From:	Product Management	Date:	27-05-2014
For:	Sales	Ref:	PI-02-02 EN
Article:	Green Pin® Shackles with screw collar pin	Revision:	0
Subject:	Redesign on Green Pin® shackles with screw collar pin		
Note:	Main dimensions, general info and warnings can be found in our latest catalogue.

- G-4161
- G-4151
- G-4164
- G-4154
- G-4169
- G-4159

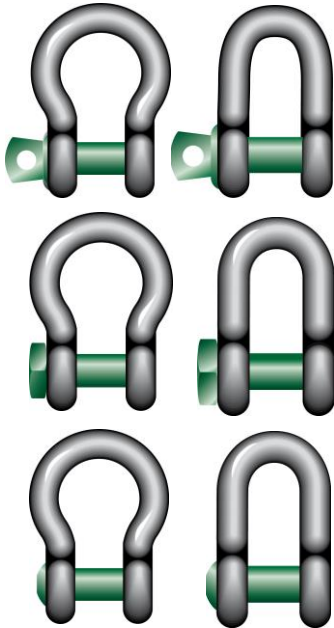
Last period, we have realized a small modification of Green Pin® shackles (WLL≥2t) with screw collar pins as follows:

Earlier design, after assembly some of the threading is visible at the shackle eye:

Current design, with hardly or no thread visible at the shackle eye:

We realized this by making a small “chamber” in the shackle eye.

The advantage of the new design is reduced wear of counter components like, wire rope, chain, rope and or synthetic web slings and their fittings.
